REED'S COVE 3RD ADDITION WICHITA, SEDGWICK COUNTY, KANSAS

RE: SUB 2004-08 -- Final Plat of Reed's Cove Third Addition

At the regular meeting of the Subdivision Committee of the Metropolitan Area Planning Commission on Thursday, February 26, 2004, the above captioned plat was considered. The action of the Committee was to approve the final plat, subject to the following staff comments:

CASE NUMBER: SUB 2004-08 -- REEDS COVE THIRD ADDITION

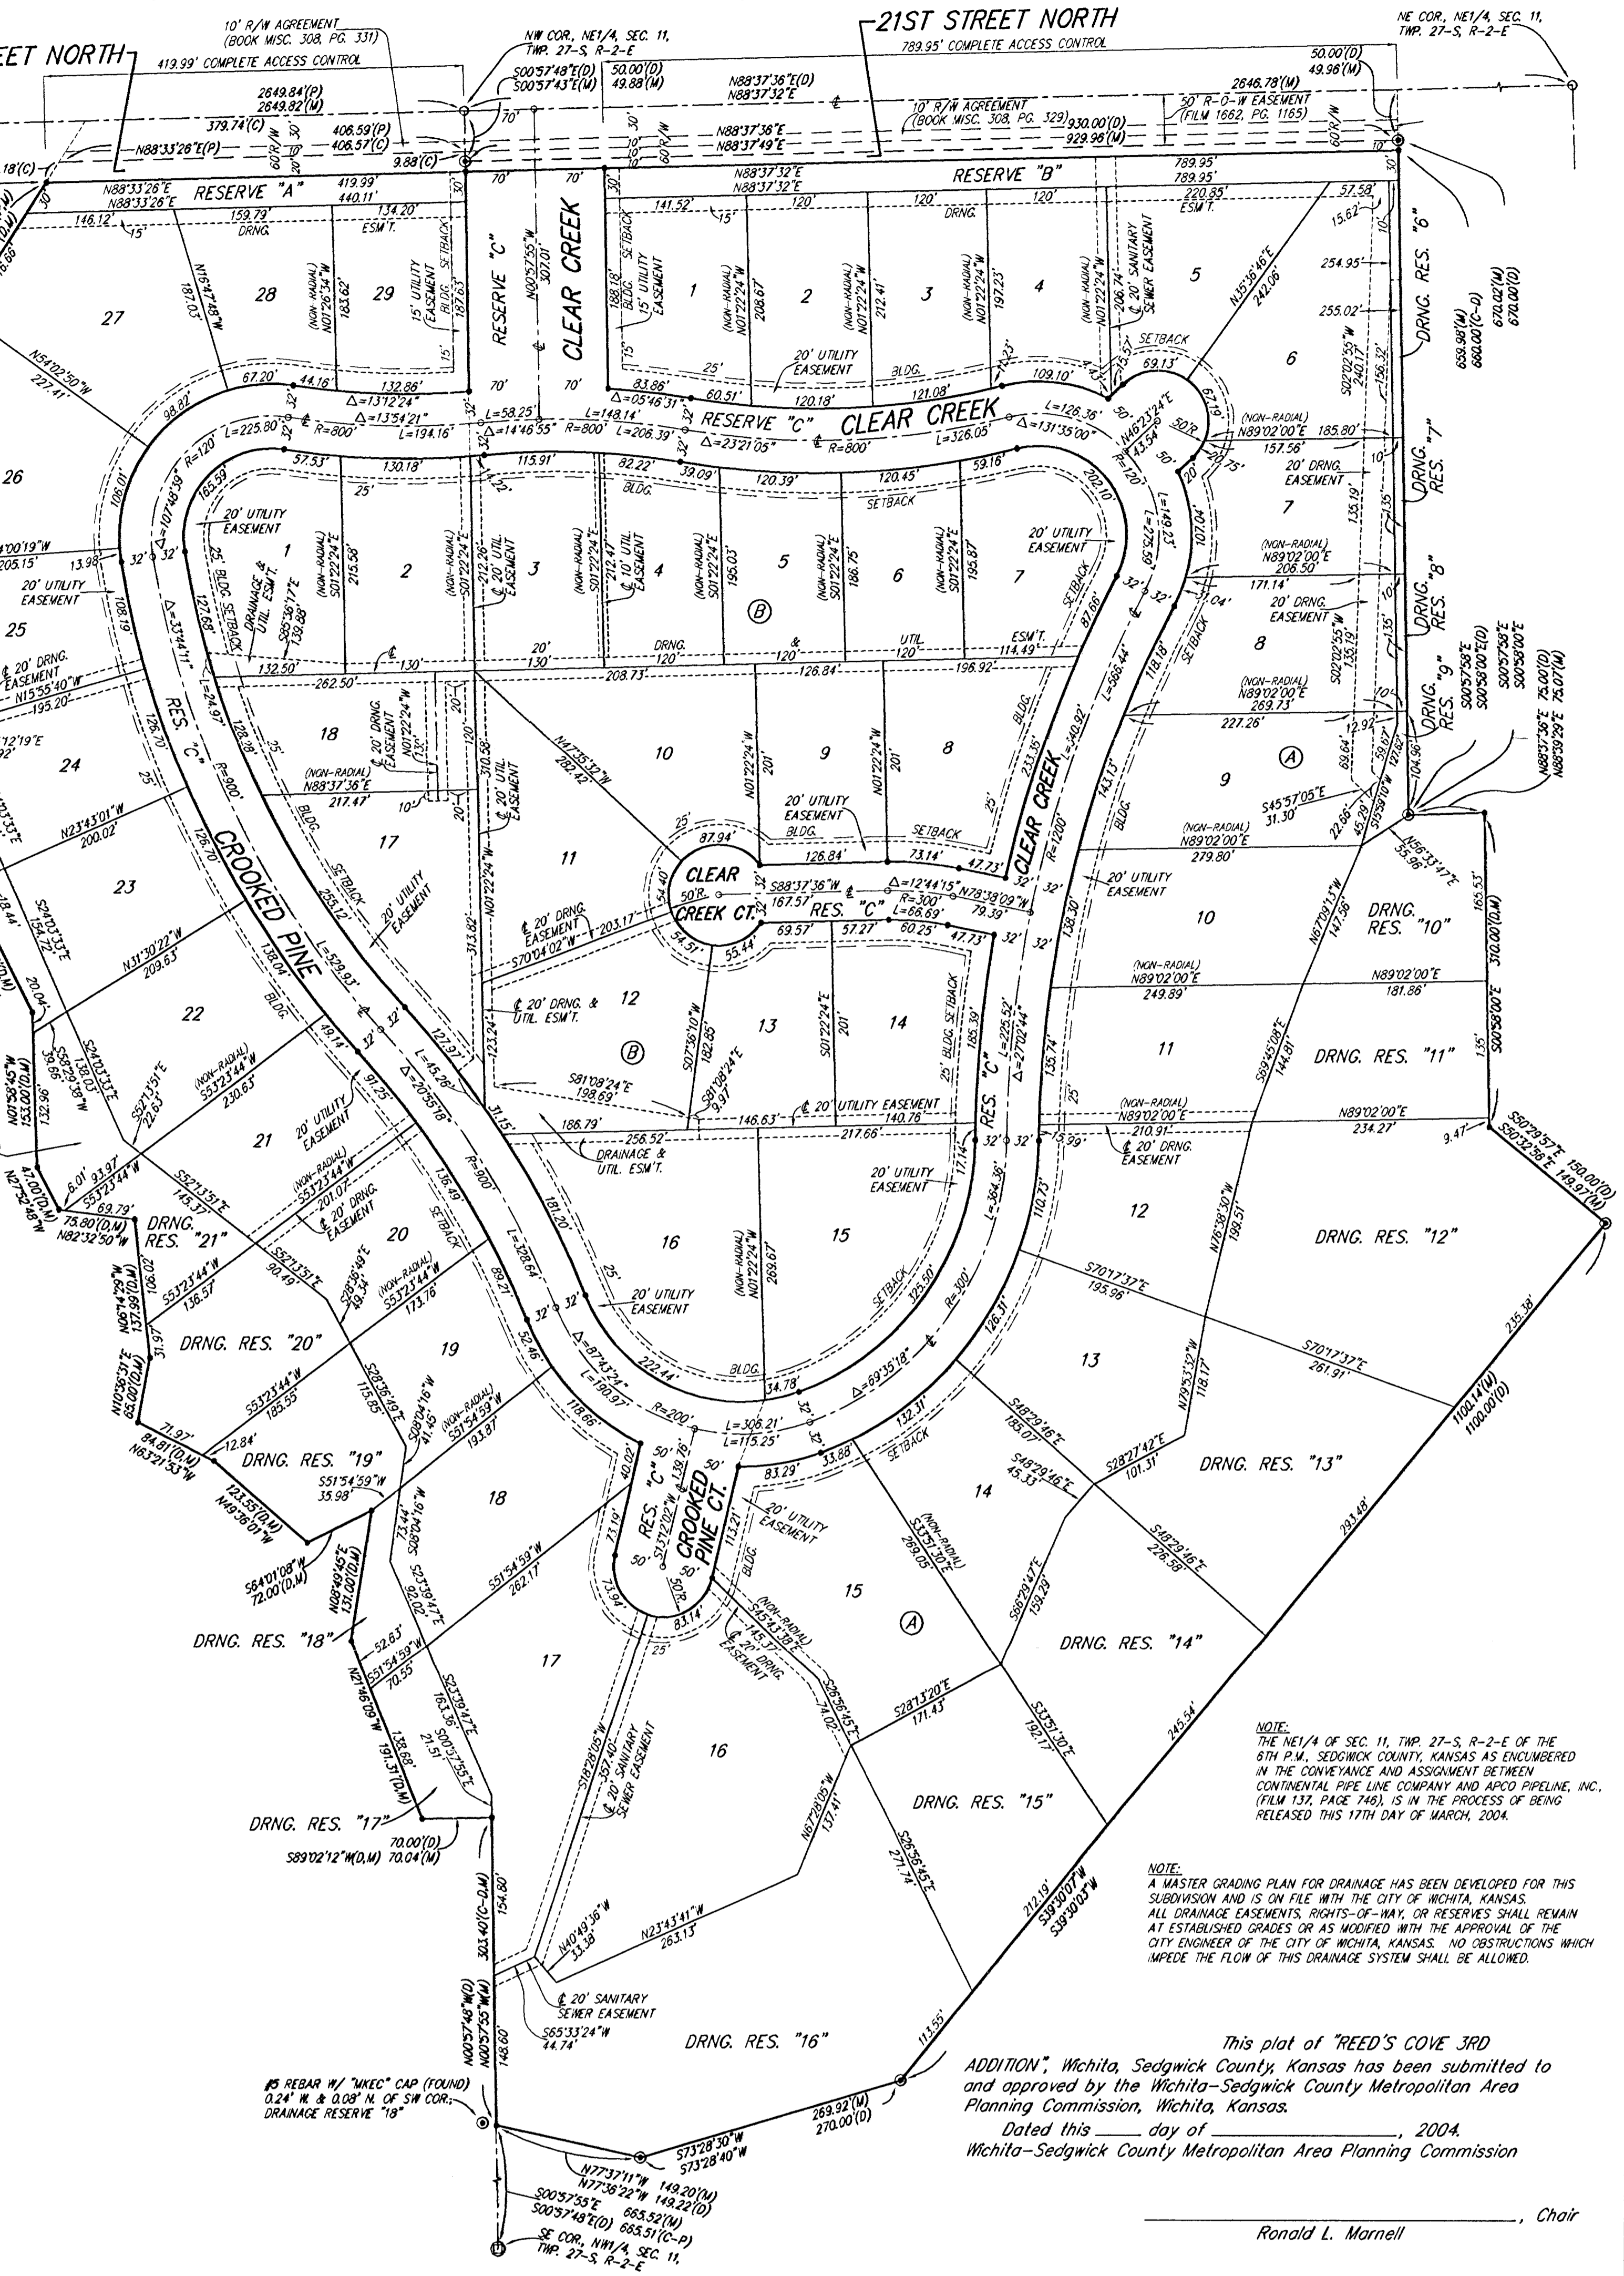
- J. The reserves being platted as private streets shall be shown appropriate street names.
- K. In accordance with the KS Wetland Mapping Conventions under the Memorandum of Understanding between the USDA-NRCS; USEPA; USACE; and USF&WS, this site has been identified as one with potential wetland hydrology. The US Army Corps of Engineers (USACE) should be contacted (316-322-8247) to have a wetland determination completed."

- N. The drainage reserves "20" through "29" need to be referenced in the plat's text.
- O. GIS needs to comment on the plat's street names. *The entrance should be Clear Creek. The loop street should be Crooked Pine and Clear Creek.*

- P. A bold solid line is needed between the 21st St. North right-of-way line and Reserve C.
- Q. County Surveying advises that the benchmark needs a better description.

- R. The Applicant needs to verify the location of the pipeline easement indicated in the platting binder. The easement shall be shown if encumbering this plat, or verification provided that it is off-site or has been released.

- S. The plat's text shall include language that a drainage plan has been developed for the plat and that all drainage easements, rights-of-way, or reserves shall remain at established grades or as modified with the approval of the applicable City or County Engineer, and unobstructed to allow for the conveyance of stormwater.

- AA. The representatives from the utility companies should be prepared to comment on the need for any additional utility easements to be platted on this property. Westar Energy and SBC have requested additional easements.
